Service Bulletin

Bulletin No.: 21-NA-149

Subject: Engine Wire Harness Chafing / IPC Gauges Sweep / IPC Warning Message / SES/Check Engine/MIL / No Start / No Crank / Runs Rough / Stalls / Reduced Engine Power / Various DTCs

5324748

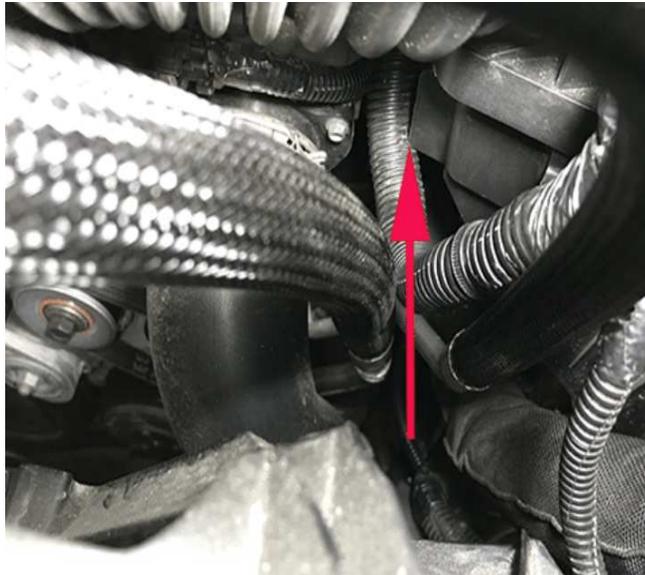
<p>Cause 1</p>	<p>This Cause pertains to vehicles equipped with engine 2.7L, L3B only.</p> <p>These concerns may be caused by engine harness contact with under hood components.</p> <p>Caution: This Document Only Applies To VINs NOT Covered by Customer Satisfaction Program N192219370 Please Verify In VIS Before Proceeding</p> <p>Shown below are areas that should be inspected for this concern.</p> <p>Inspect the engine harness as it crosses over top of the Camshaft Carrier Cover.</p> <p>Harness damage can occur at any point across the Camshaft Carrier Cover.</p> <p>Typical inspection locations shown below.</p>  <p style="text-align: right;">5394681</p> <p>Example of engine wiring harness damage at Camshaft Carrier Cover shown below.</p>

5394683

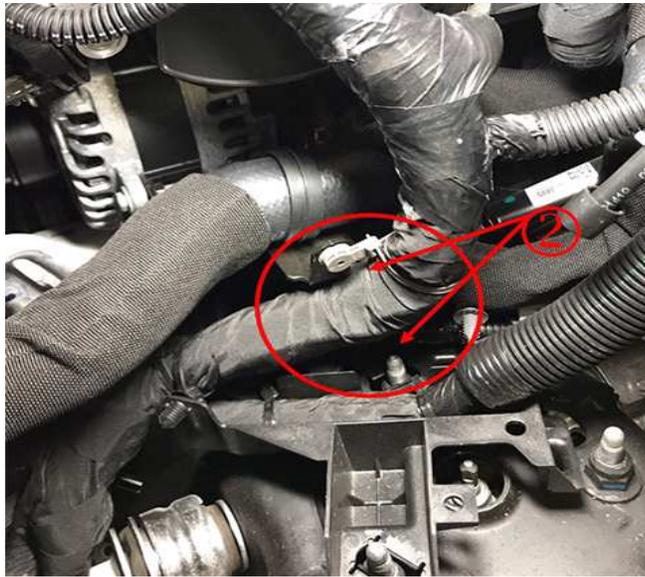
Inspect the engine harness at the Lower Air Cleaner Housing as shown below.

5324752

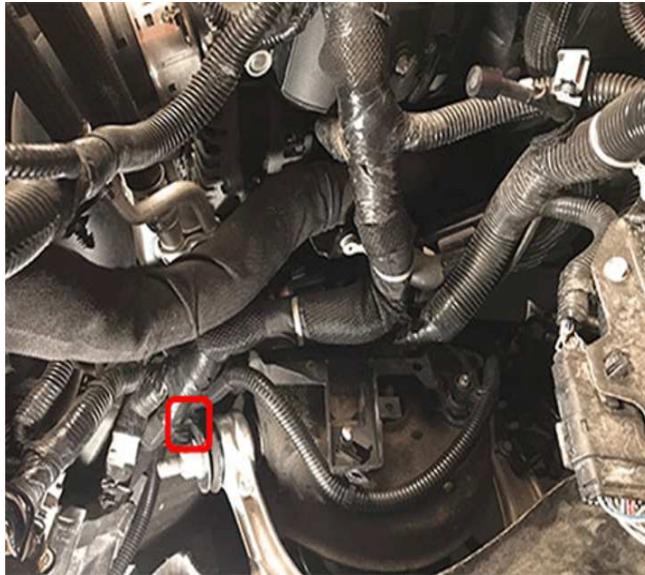
Example of engine harness damage, Lower Air Cleaner Housing removed shown below. Inspect the engine harness at the Generator Bracket and Left Front Coil Spring stud as shown below.

Note: Under normal driving conditions, the engine will rock back and forth in its mounts.

This may result in harness contact with this bracket that may not be present during engine off inspections.

Careful visual inspections are necessary to isolate areas of contact.

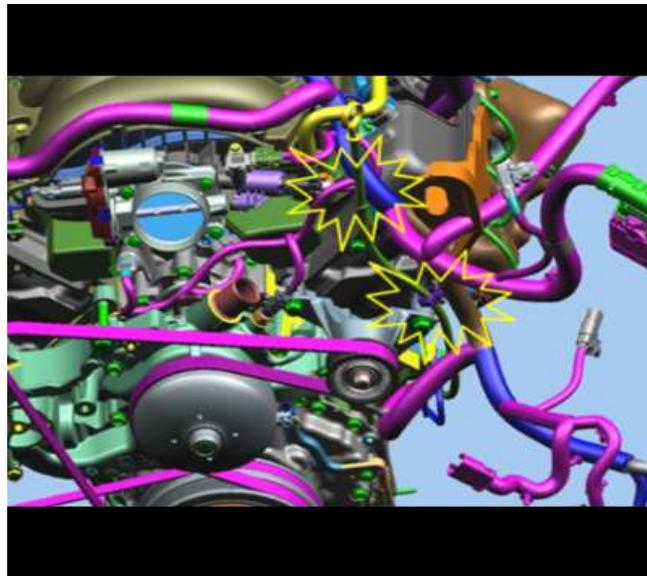
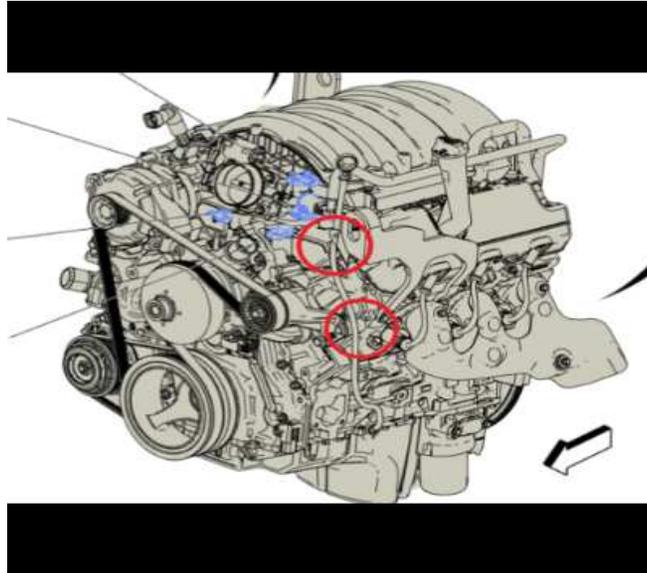
These concerns could be caused by engine wiring harness chafe on underhood components at various locations such as: Front corner of the left hand cylinder head, drive belt idler pulley bracket, or oil dipstick bracket; noted by the circled and starred areas in the graphics above.

This harness chaffing could cause shorting of any number of circuits to ground. Due to the number of circuits in the harness, there is a wide variety of different symptoms that could occur depending on which circuit(s) are damaged.

To correct this concern, repair the damaged wiring following the SI wire-to-wire repair procedures. Once repaired, protect and reposition the engine wiring harness to prevent future harness damage.

6163833

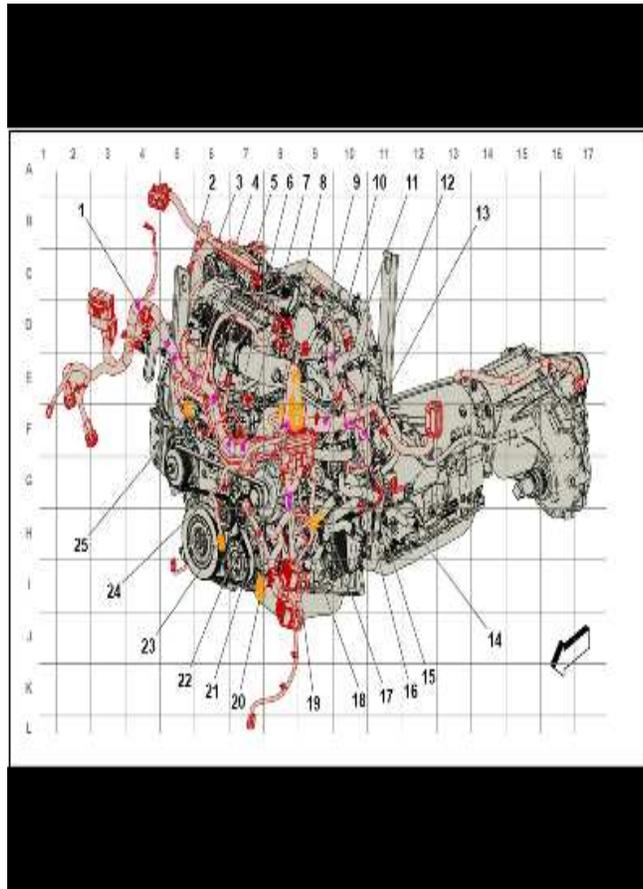
1. The engine harness pinched/shorted/chaffed at grid coordinates G-8, as shown above. This location is approximately 18 inches from the ECM connectors (1) and on top of the generator (2), as shown below. Due to the number of circuits in the harness, there is a wide variety of different symptoms that could occur, depending on which circuit(s) are damaged.

Inspect areas designated by the graphics and call-outs in Cause # 3.

In many cases, the ECM has been unnecessarily replaced for these concerns. Please thoroughly inspect the areas shown above and follow published SI diagnostics before any parts are replaced. If any concerns are found, then follow SI Wiring and Connector repair instructions to correct the concern.

5694712

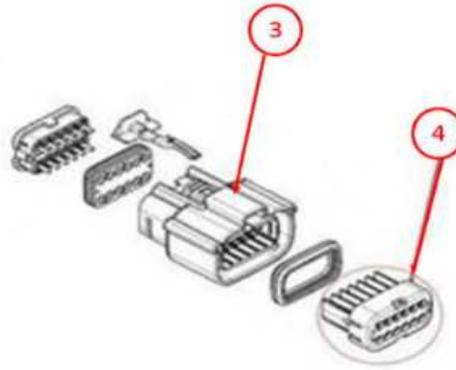
2. The engine harness shorted/chaffed at grid coordinates C-9, as shown above. The engine harness could be shorted out on the PVC hose clamp at the crankcase pressure regulator, as shown below (6). This is located approximately 4 inches from the crankcase sensor connector pigtail harness breakout.

5643651

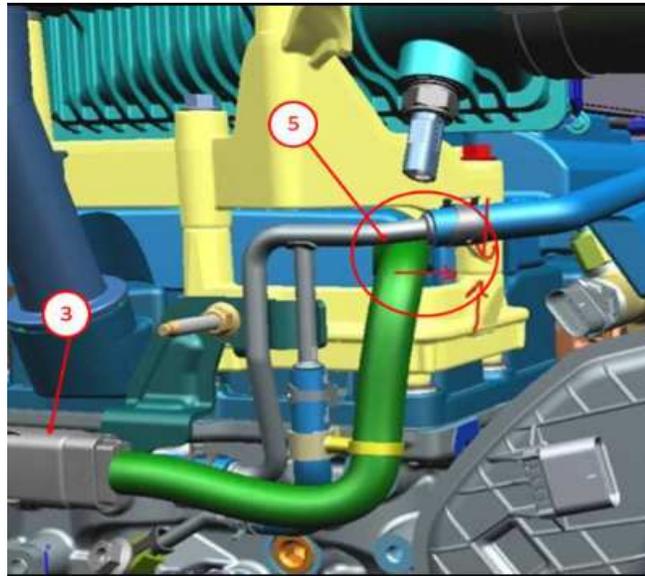
1. Inspect for poor terminal tension at connector X160, shown in the grid above, as callout 25. While inspecting X160 make sure the terminal locking feature (4), shown below, is not missing.

2. Inspect the fuel injector connectors to make sure they are fully connected/seated.
3. Inspect the fuel injector wiring harness near the X160 connector (3) for being pinched/shorted/chaffed, as shown below (5).

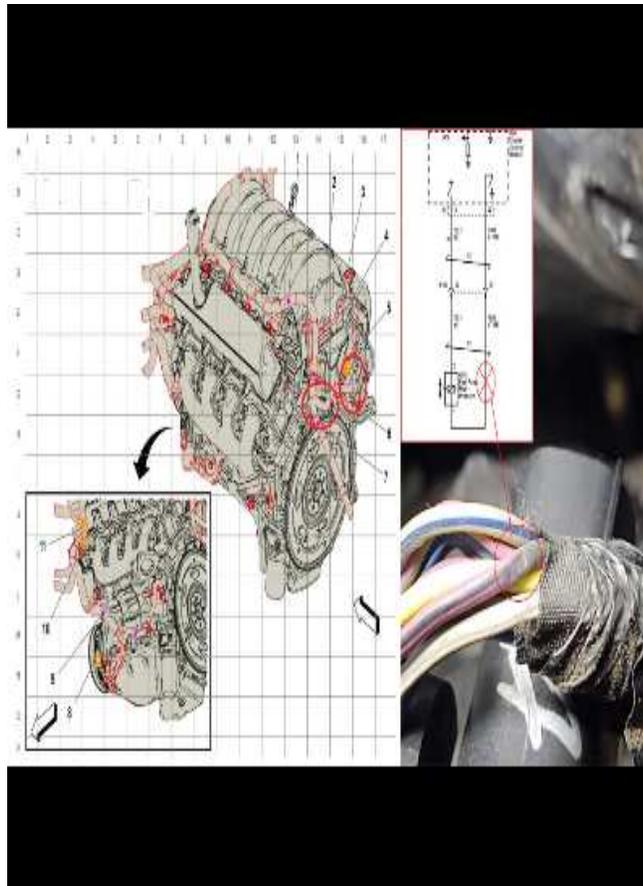
Examples of extreme wire chaffing.

An example of firewall insulator chaffing

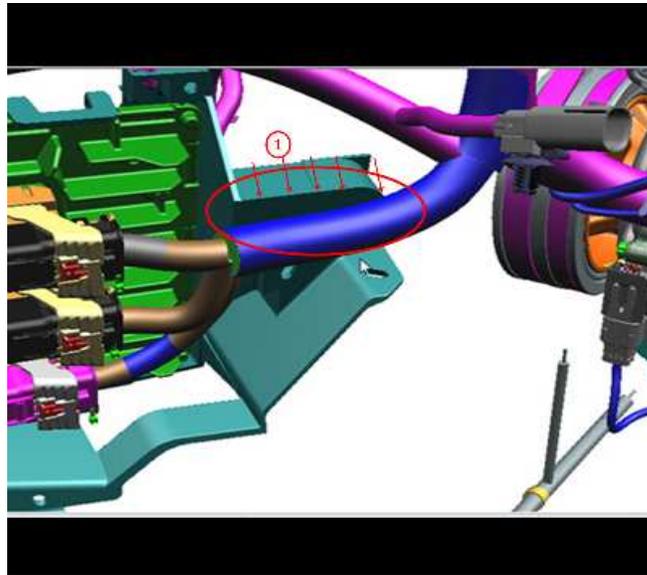
Other areas of concern.

The cause of the condition may be an engine wire harness clip was removed during production due to ergonomic issues (hand clearance and branch stiffness). This led to an uncontrolled branch that came into contact with a sharp edge (1) & (2) on the ECM/TCM bracket, driver side upper control arm, and/or shock tower and caused chaffing during engine vibration and roll.

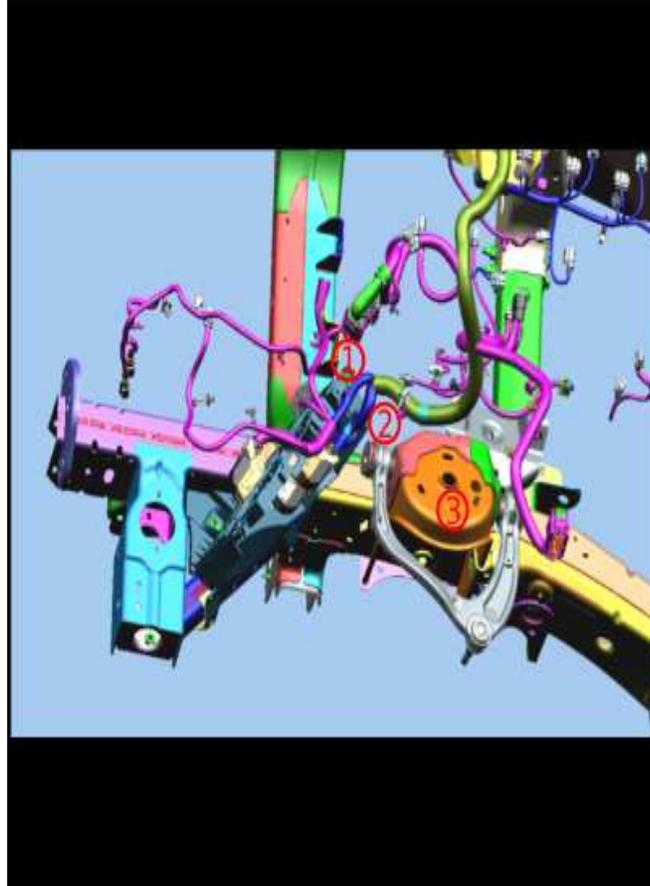
3. Locate the three contact points where the wire harness is chaffing, the ECM/TCM black bracket (1), the upper control arm (2), and the shock tower bolt (3).

1. Lift and support the vehicle. Refer to *Lifting and Jacking the Vehicle* in SI.
2. Remove driver side tire and wheel and driver wheelhouse liner. Refer to *Tire and Wheel Removal and Installation*, and *Front Wheelhouse Liner Replacement* in SI.

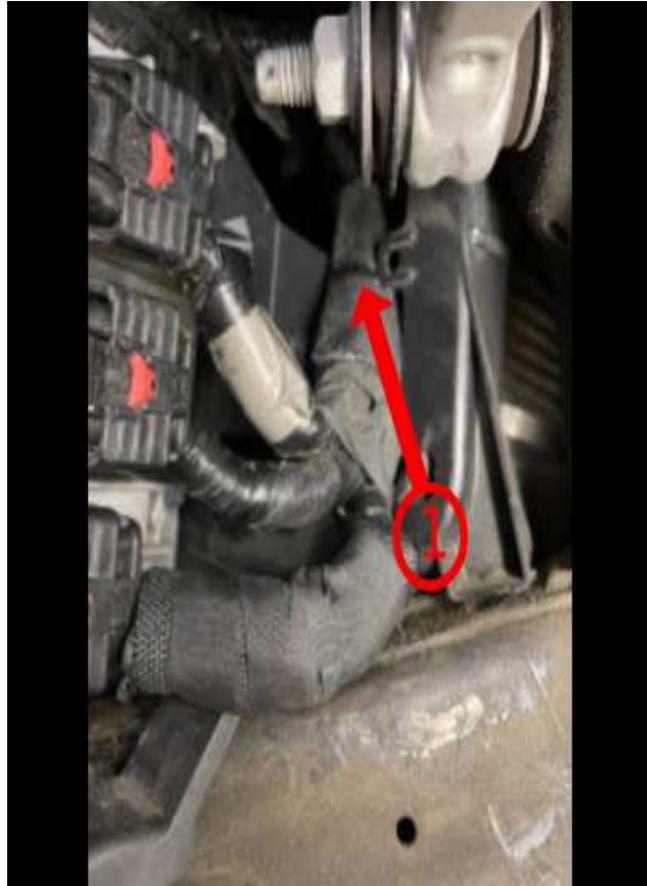
4. At the ECM/TCM bracket, locate the wire harness laying against the ledge (1).

5. Wrap the wire harness with the shorter Engine Harness Sleeve then utilizing zip ties and two small holes in the bracket (1).
